Access Compliance Report

Public Rights-of-Way (Curb Ramps)

Intersection ID: 10009418	Main Street: E_10TH_ST	Cross Street: N_BREVARD_ST	Location: E
ADA ID: 73F0D83A4FA5	Ramp Type: PerpDiag	Initial Pass/Fail: Fail	Overall Compliance: No Severity Score: 13.75

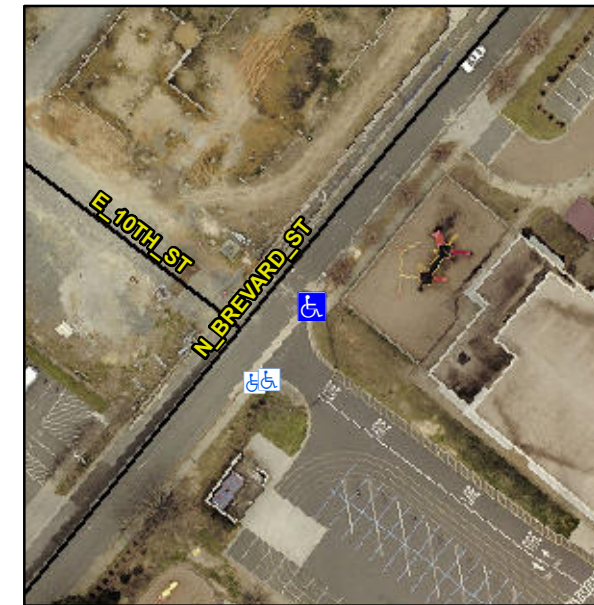
Not Found, R304.2.2, R304.5.3

Compliance	Description	Data	Compliance	Description	Data
N/A	Ramp Length (in)	49.0	No	Ramp Slope (%)	8.6
Yes	Ramp Width (in)	48.0	No	Ramp XSlope (%)	3.3
N/A	Flare Type LT	N/A	N/A	Flare Type RT	N/A
N/A	Flare Slope LT (%)	N/A	N/A	Flare Slope RT (%)	N/A
N/A	Flare Traversable LT?	N/A	N/A	Flare Traversable RT?	N/A
N/A	Landing Length (in)	N/A	N/A	DWS Provided?	N/A
N/A	Landing Width (in)	N/A	N/A	DWS Contrast?	N/A
N/A	Landing Slope (%)	N/A	N/A	DWS Length (in)	N/A
N/A	Landing X Slope (%)	N/A	N/A	DWS Full Width?	N/A
N/A	Landing Curb? (Y/N)	N/A	N/A	DWS Offset (in)	N/A
N/A	Shared Landing?	N/A			
N/A	Gutter Ponding?	N/A	N/A	Gutter Slope (%)	N/A
N/A	Gutter Lip Ht (in)	N/A	N/A	Gutter X Slope (%)	N/A
N/A	Painted X Walk1?	No	N/A	Painted X Walk2?	No
	X Walk 1 Direction	To NW		X Walk 2 Direction	To SW
N/A	X Walk 1 Width (in)	N/A	N/A	X Walk 2 Width (in)	N/A
	X Walk 1 Slope (%)	2.3		X Walk 2 Slope (%)	1.5
	X Walk 1 X Slope (%)	2.7		X Walk 2 X Slope (%)	0.1

Remove & Replace Curb Ramp With Two New Directional Ramps or Equivalent.
